METROPOLITAN GOVERNMENT OF NASHVILLE AND DAVIDSON COUNTY

STAFF RECOMMENDATION 2203 25th Avenue South June 18, 2014

Application: New construction—infill; Setback determination
District: Hillsboro-West End Neighborhood Conservation Zoning Overlay
Council District: 18
Map and Parcel Number: 10415003300
Applicant: Manuel Zeitlin
Project Lead: Melissa Baldock, melissa.baldock@nashville.gov

Figure 1. 2203 25th Avenue South

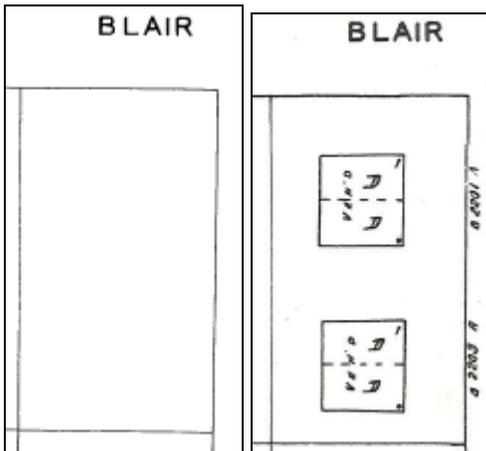
Background: 2203 25th Avenue South is duplex located between Ashwood Avenue and Blair Boulevard (Figure 1). The structure was constructed c. 1955, later than the majority of the houses in the area. It is a non-contributing building. It has a smooth face concrete block foundation and has no overhanging eaves. While most of the historic structures in the neighborhood face the east-west streets, 2203 and its neighbor at 2201 25th Avenue South face the north-south streets. These two structures were developed on what is generally one lot for the neighborhood, and therefore they have unusually shallow depths (see Figures 2 & 3).

1 SITE PLAN & LAYOUT
1" = 20'-0"

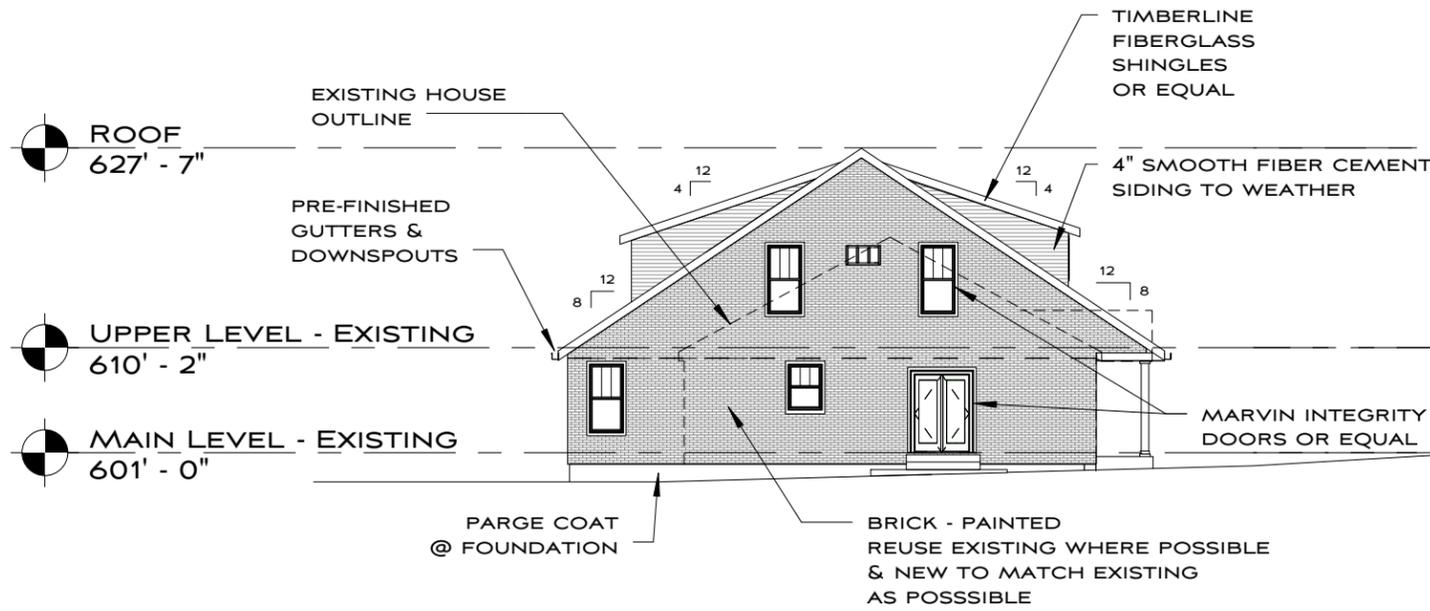
Setback & Rhythm of Spacing: The side setbacks will not change with the proposed alterations and expansion of the house. The structure will be more than fifteen feet (15') from both side property lines. The applicant is requesting a change to the rear setback. With the rear addition, the rear setback is proposed to be ten feet (10'), but bulk zoning requires twenty feet (20'). Staff finds the ten foot (10') setback to be appropriate for several reasons. The lot is irregularly shaped for this portion of the Hillsboro-West End neighborhood and is unusually shallow at ninety-feet (90'). Most lots nearby are approximately one hundred and sixty feet (160') deep. The rear property line for this structure is the side property line for the property at 2503 Blair Boulevard, and typically side property setbacks are just five feet (5'). In addition, the addition is just one-and-a-half stories and is appropriately scaled, and therefore the proposed setback will not significantly affect neighboring properties. Lastly, in October 2013, the MHZC approved a similar setback for the house next door at 2201 25th Avenue South (Figures 4 & 5). Staff finds that the setback determination, in this instance, is appropriate and meets section II.B.1.c. of the design guidelines.

2203 25TH AVE S
NASHVILLE, TN 37212
ELEVATIONS

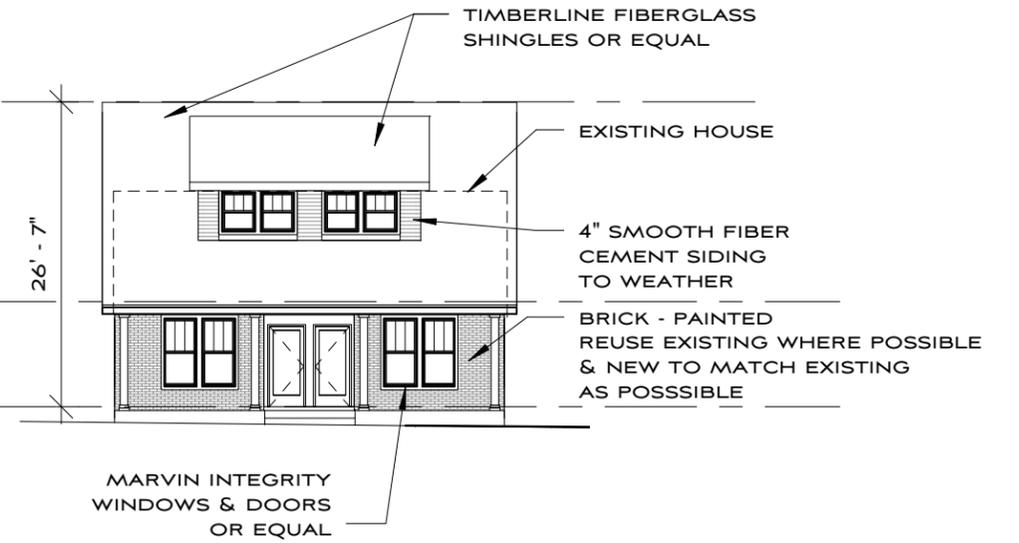
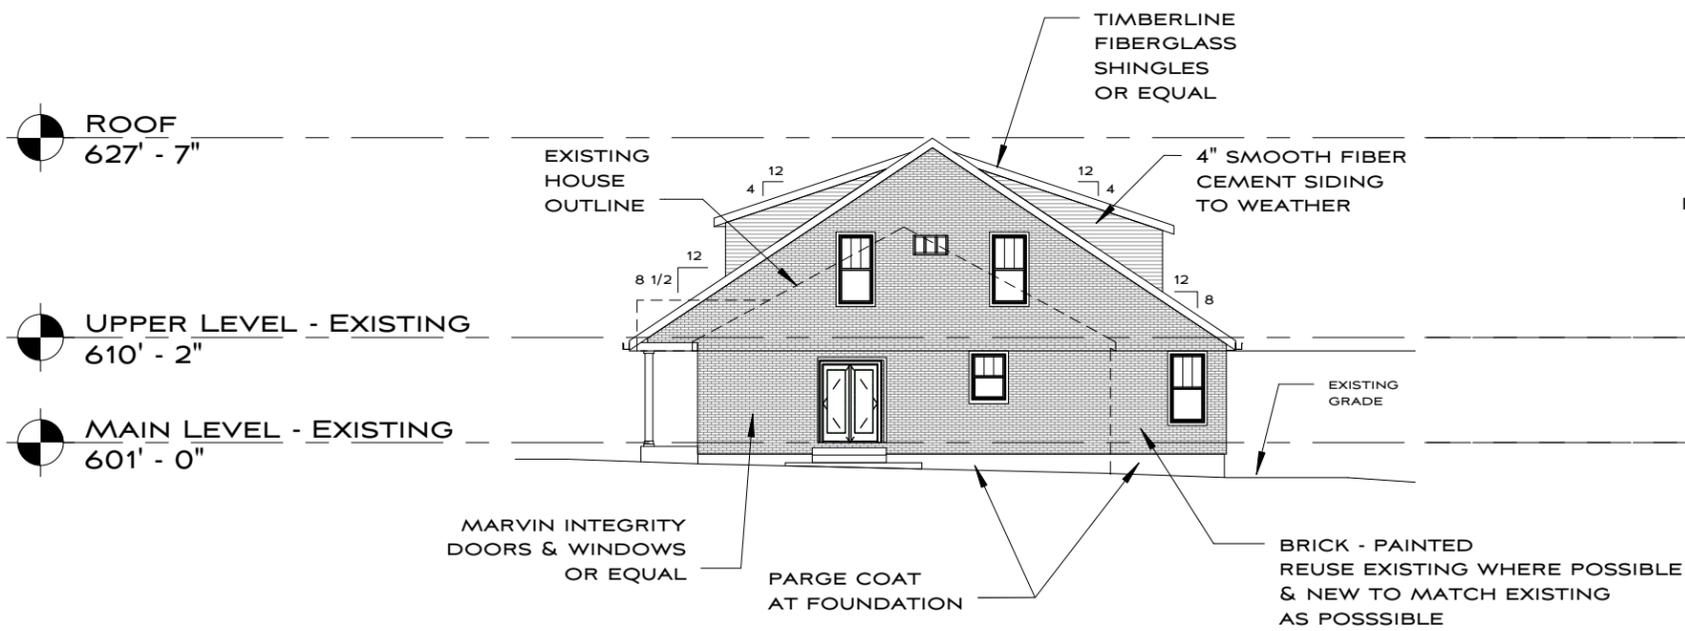
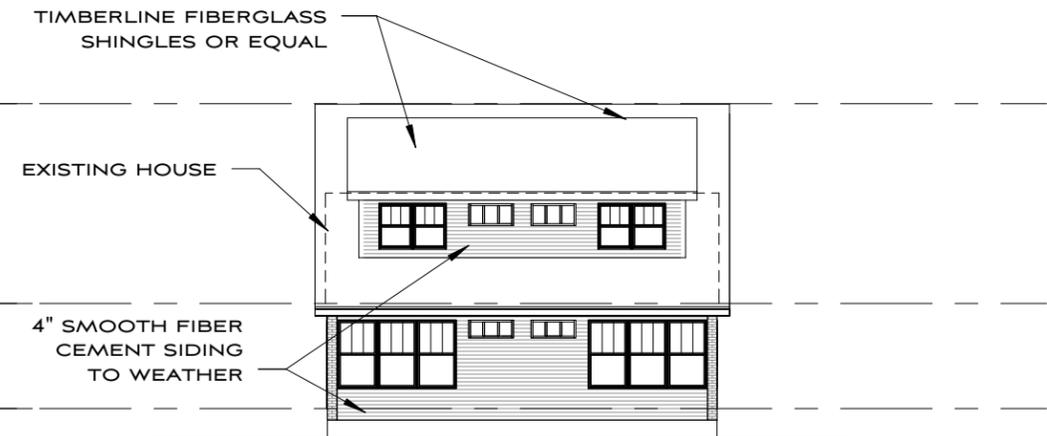
Height & Scale: The project will create a taller one-and-a-half story structure. The new design will have an eave height similar to the existing eave height, which is approximately nine feet, six inches (9'6") from grade. Its foundation height will match the existing foundation height, and will be approximately one foot (1') tall at its highest point in the front. The house's ridge height will be approximately twenty-six feet, seven

Roof form: The new roof form will be a side gable with a slope of 8/12, which is a common roof form in the historic overlay. The house will have both a front and a rear shed dormer with a slope of 4/12. The dormers are both set back a minimum of two feet (2') from the wall below, are inset at least two feet (2') from the side walls, and are located below the ridge of the house. Staff finds that the project's roof forms meet section II.B.1.e. of the design guidelines.

Proportion and Rhythm of Openings: The project does involve altering the existing window and door openings. The window openings are all generally twice as tall as they are wide, thereby meeting the historic proportions of openings. There are no large expanses of wall space without a window or door opening. Staff finds the project's proportion and rhythm of openings to meet Section II.B.1.g. of the design guidelines.

2203 25TH AVE S
NASHVILLE, TN 37212
MAIN LEVEL PLAN

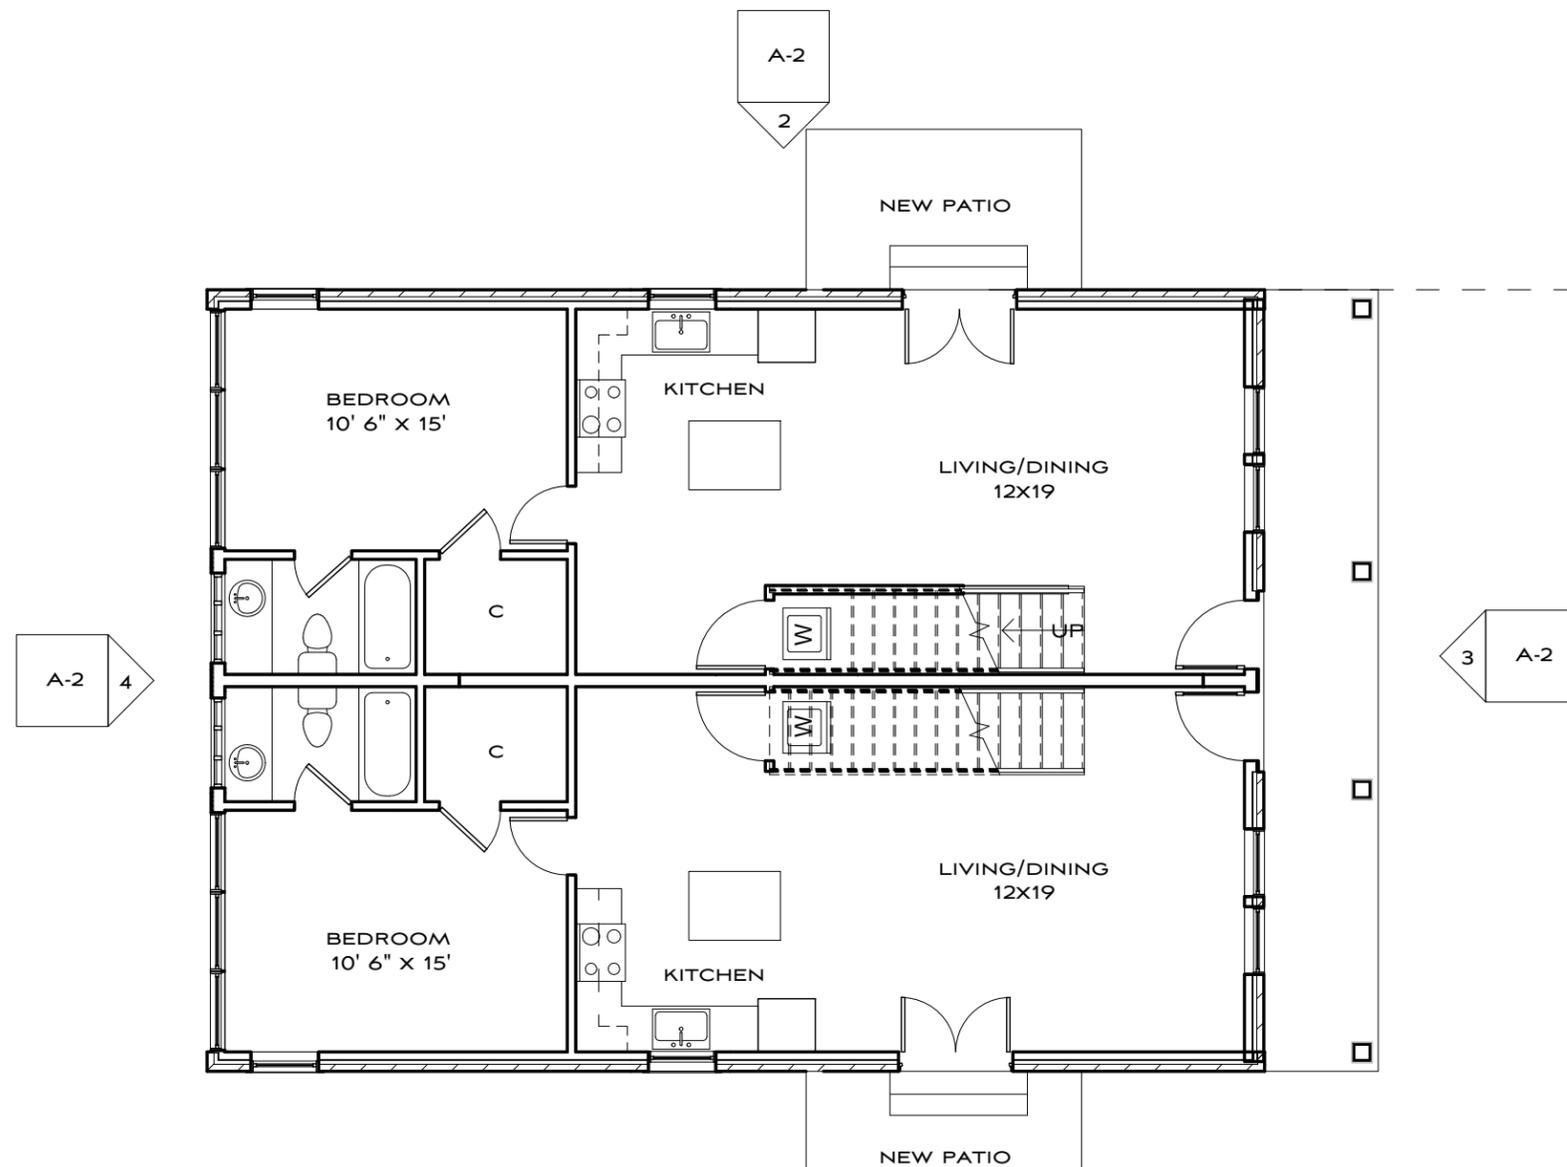
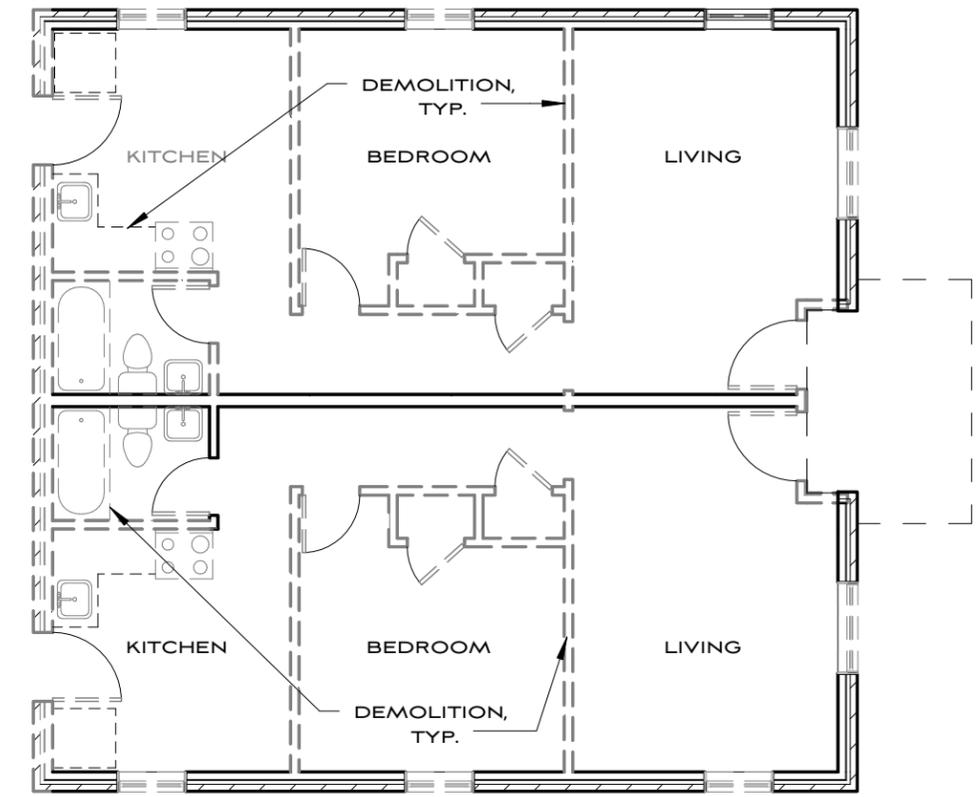
Orientation: The structure will continue to be oriented towards 25th Avenue South, which is appropriate. The duplex will have two entrances situated on the center of the front façade, both of equal prominence. The project will retain the central walkway leading from the street to the front porch. The new, extended front porch is proposed to only be five feet (5') deep, which is the same depth of the existing stoop. The design guidelines ask that porches be a minimum of six feet (6') deep, and staff therefore asks that the porch be increased in depth to six feet (6'). There is an existing curb cut and driveway, and the plans do not indicate any change to this existing driveway. With the increase in the porch's depth, staff finds that the project meets section II.B.1.f. of the design guidelines.

1. Staff approve the asphalt shingle color and the porch floor material;
2. The depth of the front porch be increased to six feet (6');
3. The HVAC units be placed in the rear, or on a side façade behind the midpoint of the house.
